Agenda Item: 8.4.1

Source: Nokia

Title: Additions to RRC procedures related to UE capabilities

Document for: Decision

Figure 1) Procedure for transmission of UE capability information

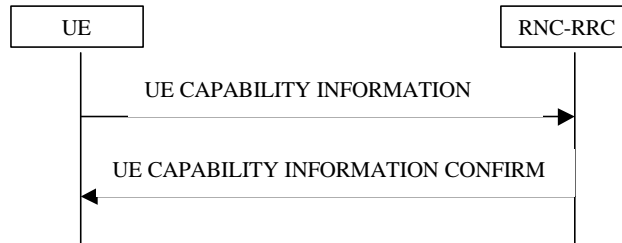
The UE transfers its capability information to the network by transmitting the UE CAPABILITY INFORMATION message ~~using acknowledged mode~~ on the DCCH. UTRAN acknowledges the successful update of UE capability by UE CAPABILITY INFORMATION CONFIRM message.

This procedure can (optionally) be performed after RRC Connection Setup procedure and also during the lifetime of the RRC Connection if the UE capability information changes (e.g. due to change in UE power class).

UE capability information can also explicitly be requested by UTRAN (see chapter 8.3.x.x).

Figure 2. UE capability Enquiry procedure.

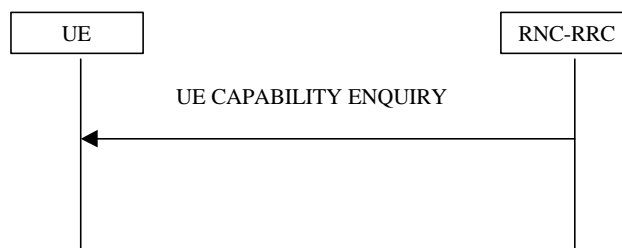
UE Capability Enquiry can be used to request UE to transmit its capability information related to any radio access network that is supported by the UE. UE CAPABILITY ENQUIRY message is transmitted on the DCCH and it includes indication of the desired UE capability information (e.g.. UE UTRAN capability information, GSM Classmark N, etc.)
